Date: June 9, 2004  
Refer To: ER 2004-0287

**SUBJECT: RESPONSE TO NOTICE OF DEFICIENCY (NOD) COMMENTS  
REGARDING THE SUPPLEMENTAL SAMPLING AND ANALYSIS PLAN  
(SAP) FOR MIDDLE MORTANDAD/TEN SITE AGGREGATE**

**Response to Notice of Deficiency (NOD) Comments  
Regarding the Addendum to the Sampling and Analysis Plan (SAP) for  
Middle Mortandad/Ten Site Aggregate (LA-UR-04-1714; ER2004-0078)**

Figure 2.2-3. Existing sampling locations at TA-05 (west) in the East Ten Site Slope Subarea

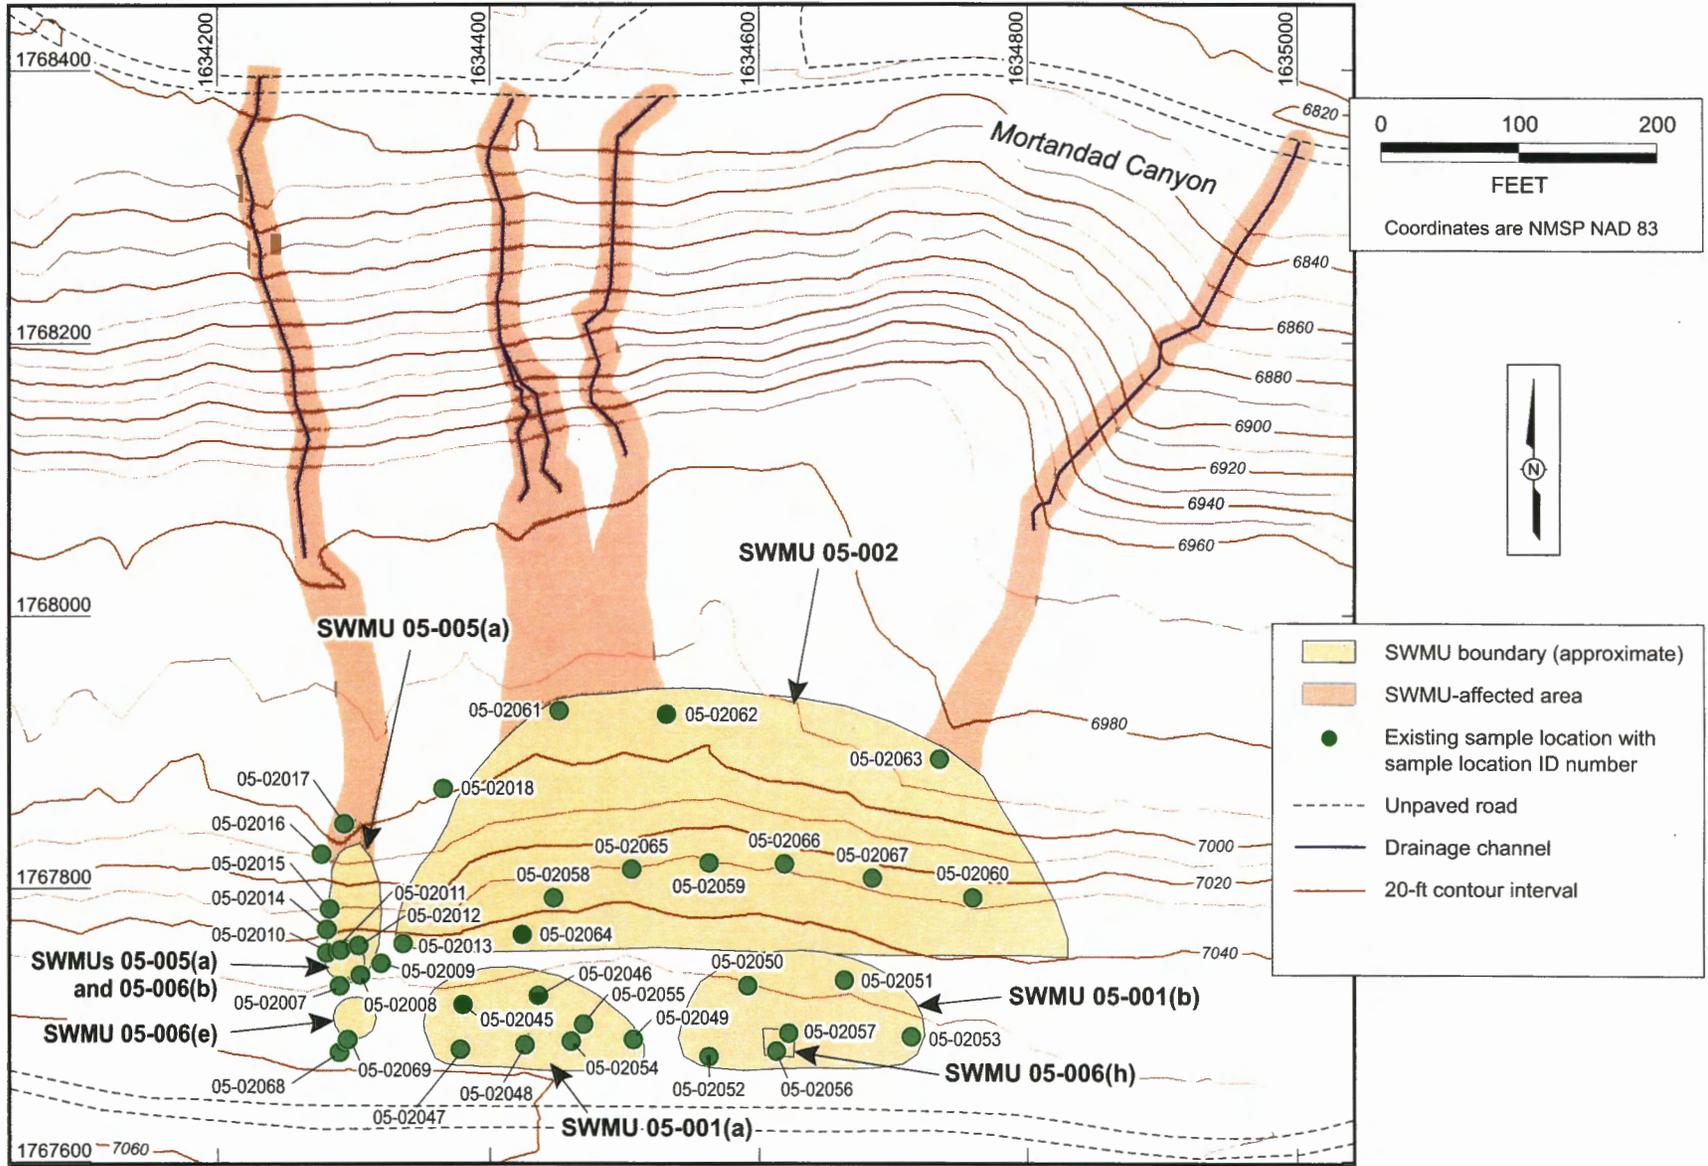
*Fix the typographical error, SWMU labeled as 05-001(h) in the Figure should have been labeled 05-006(h).*

7. The label for SWMU 05-001(h) has been changed to 05-006(h) on the appropriate figures throughout the document. This correction applies to Figures 2.2-3, 3.2-2, C-2a, C-2b, and C-2c. (See revised page 24, revised page 74, and revised Figures C-2a through C-2c.)

Figure 3.2-2. Proposed sampling locations at TA-05 (west) in the East Ten Site Slope Subarea

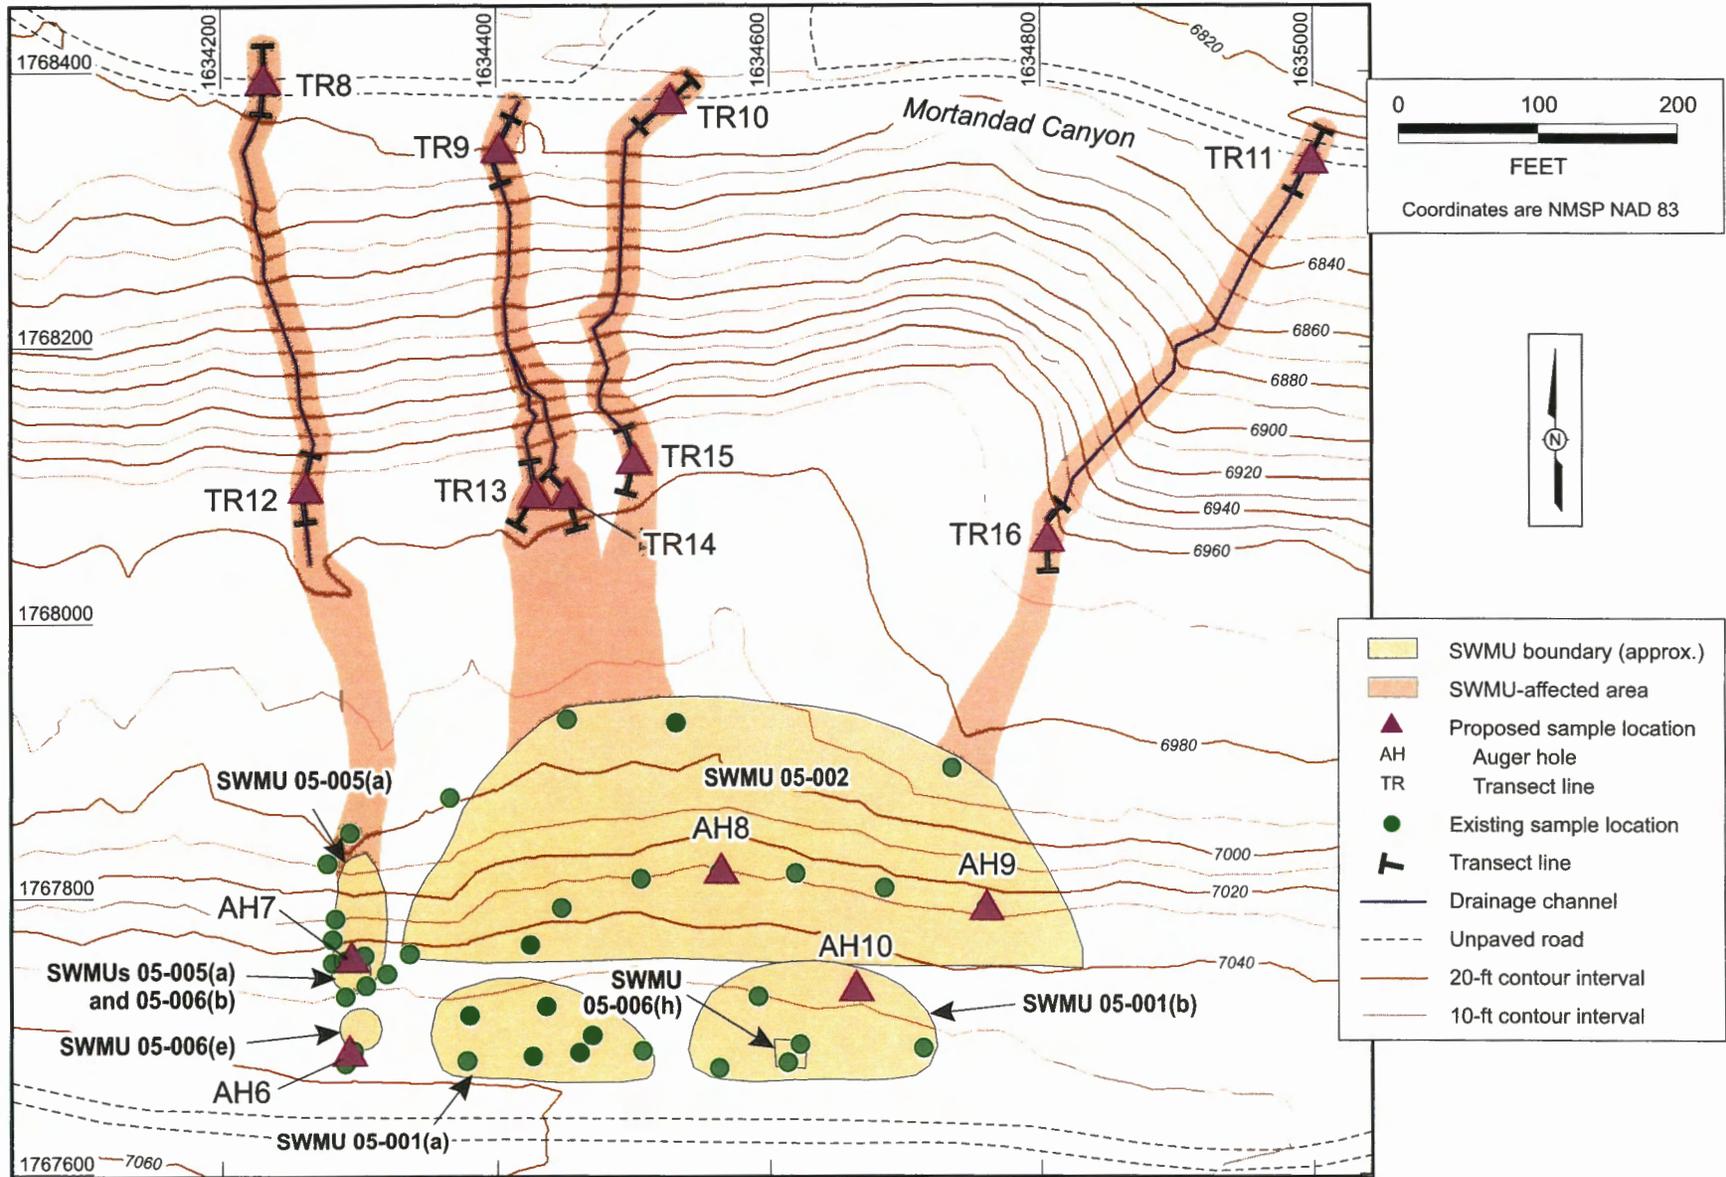
**7. Figure 3.2-2, Proposed sampling locations at TA-05 (west) in the East Ten Site Slope Subarea, page 74:**

**Revised Figure C-2d. Inorganic chemicals detected above background in sampling locations at TA-05 (east) in the East Ten Site Slope Subarea**

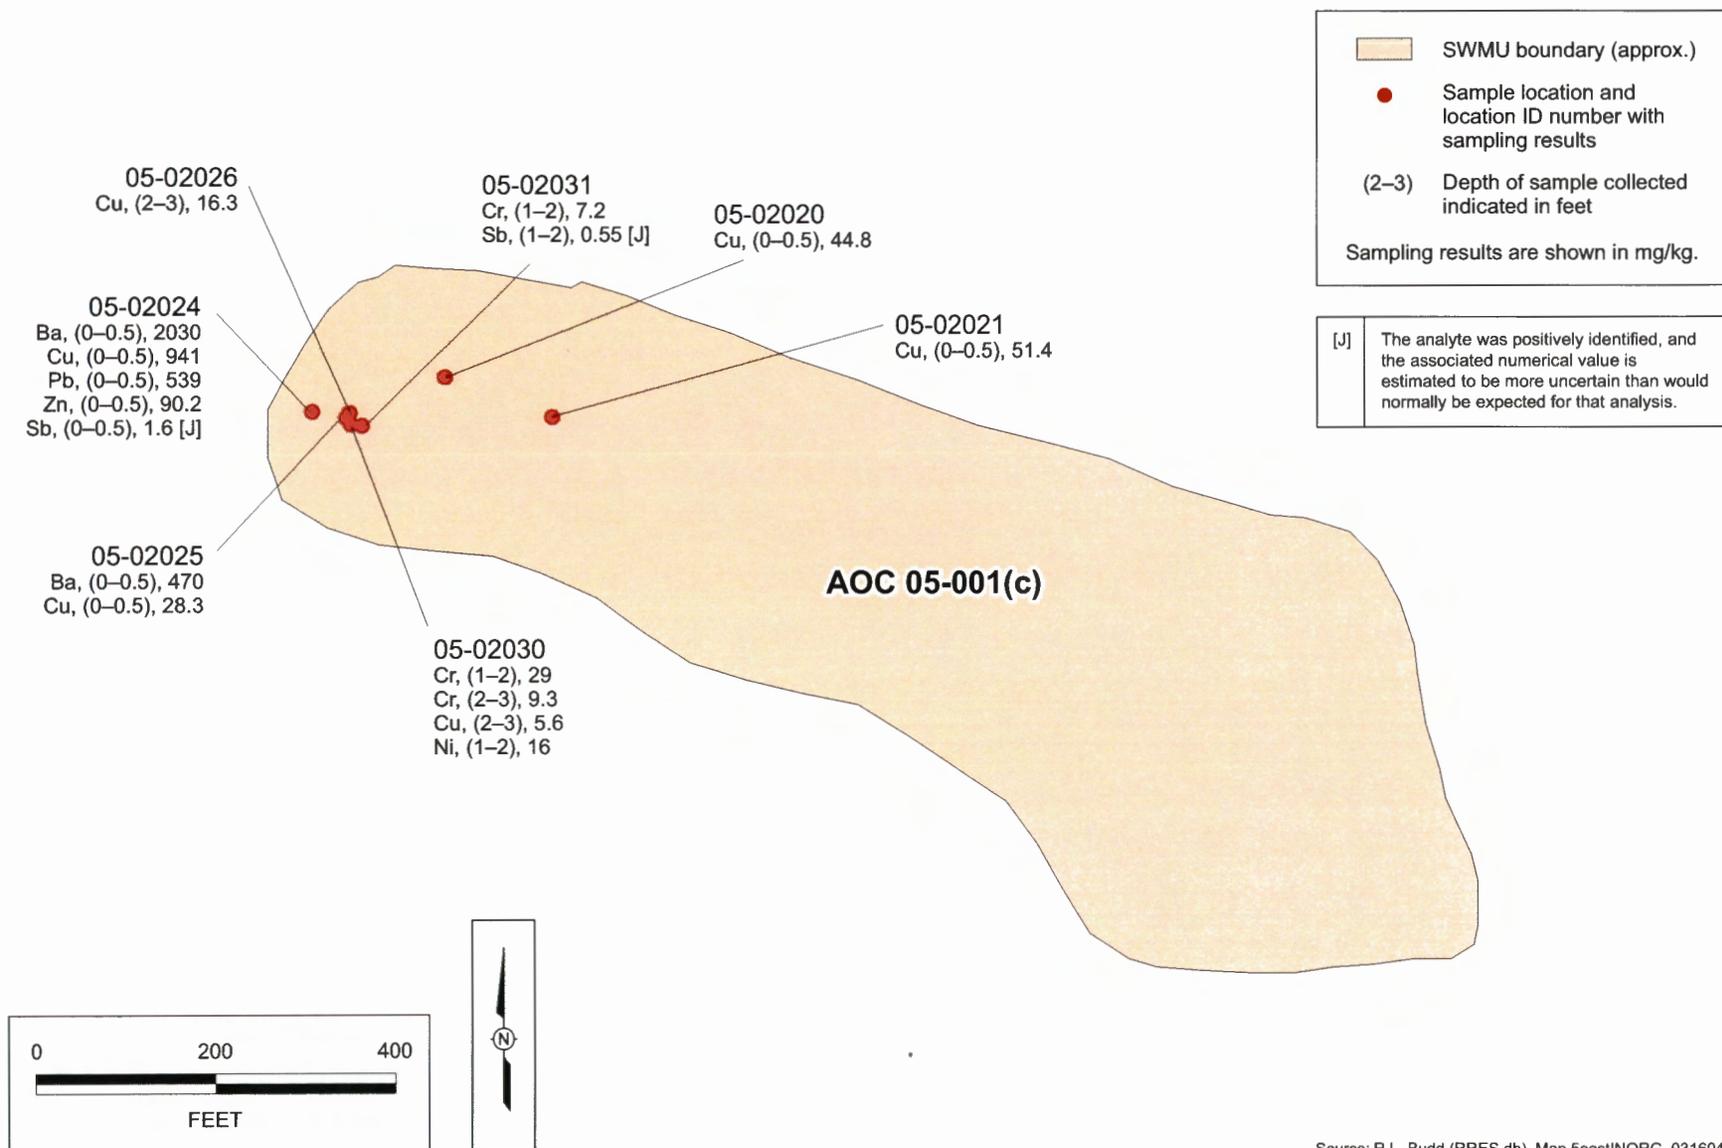
**13. Table B-2.0-2, Inorganic Chemicals with Concentrations (mg/kg) or Detection Limits at or Exceeding BVs in East Ten Site Slope Subarea, page B-14 and Figure C-2d, Inorganic chemicals detected above background in sampling locations at TA-05 (east) in the East Ten Site Slope Subarea:**

*Detected value of barium at location 05-02025 at 0-0.5 ft is noted as 4070 mg/kg in Figure C-2d, and as 407 mg/kg in Table B-2-0-2. Clarify the discrepancy and fix the typographical error.*

13. The concentration of barium shown on Figure C-2d has been changed to 470 mg/kg. (See revised Figure C-2d.) In the original report, Table B-2.0-2 showed a barium concentration of 470 mg/kg.

Revised Figure C-3a. Inorganic chemicals detected above background in sampling locations at TA-52

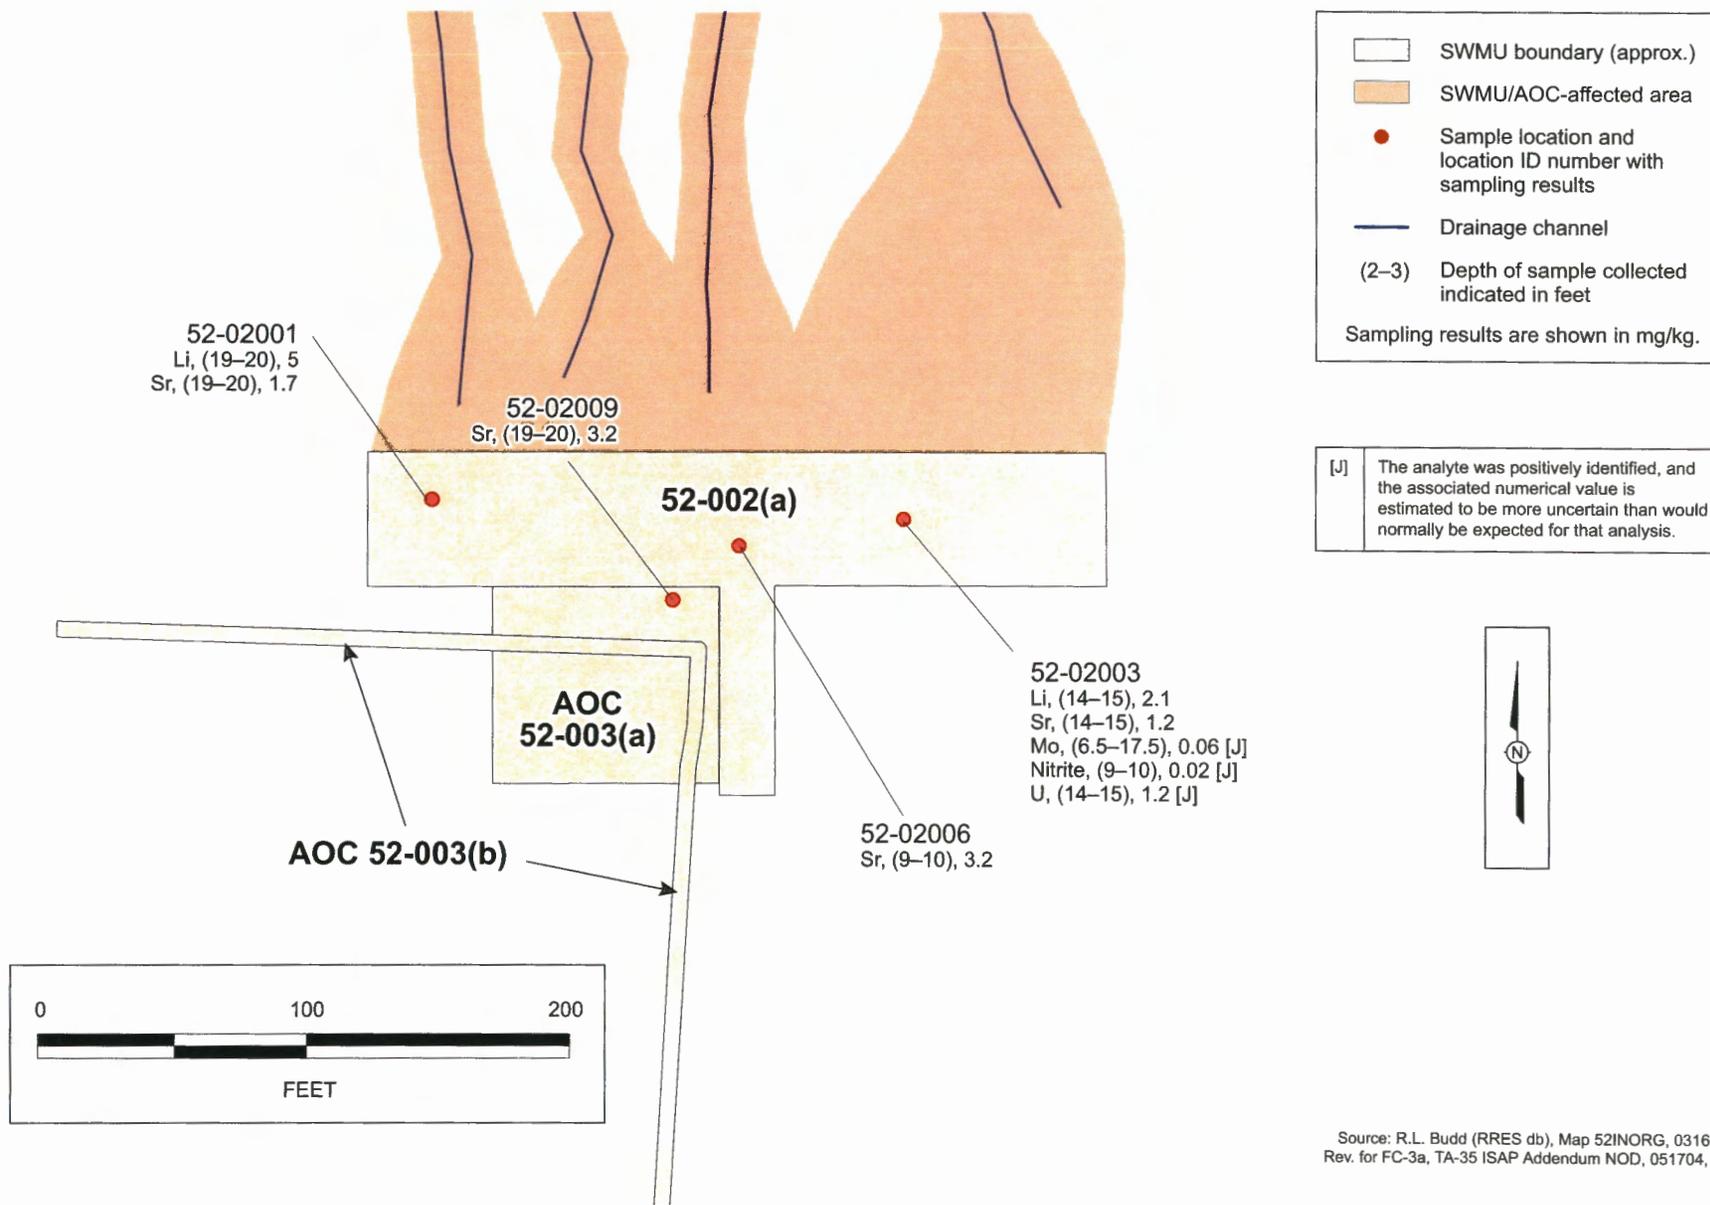
**14. Figure C-3a, Inorganic chemicals detected above background in sampling locations at TA-52:**

*Two separate sampling locations have been labeled by the same number (i.e. 52-02003); revise the figure with location IDs labeled correctly.*

14. The second point labeled Location ID 52-02003 on Figure C-3a has been changed to Location ID 52-02006. (See revised Figure C-3a.)

Revised Figure C-3c. Radionuclides detected above background in sampling locations at TA-52 in the East Ten Site Slope Subarea

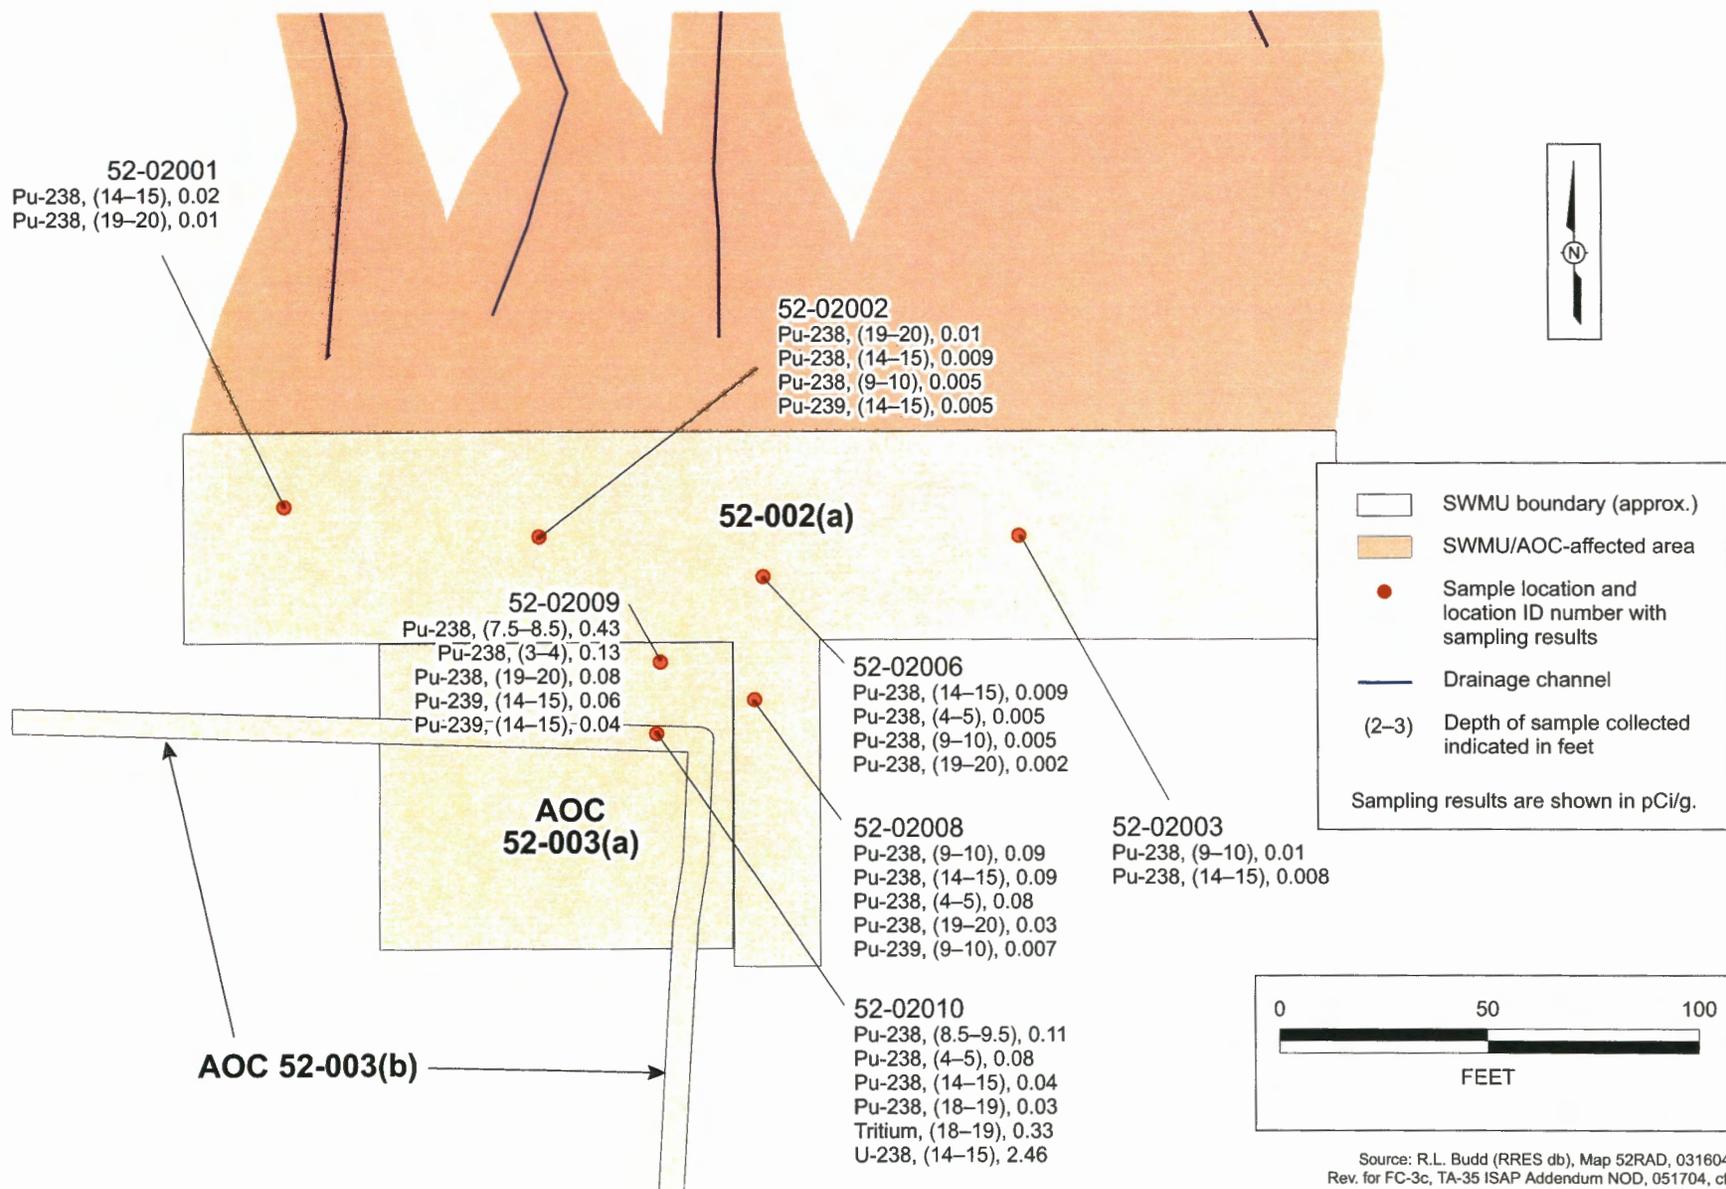
**15. Figure C-3c, Radionuclides detected above background in sampling locations at TA-52 in the East Ten Site Slope Subarea:**

*Two separate sampling locations have been labeled by the same number (i.e. 52-02009); revise the figure with location IDs labeled correctly.*

15. The second point labeled Location ID 52-02009 on Figure C-3c has been changed to Location ID 52-02010. (See revised Figure C-3c.)
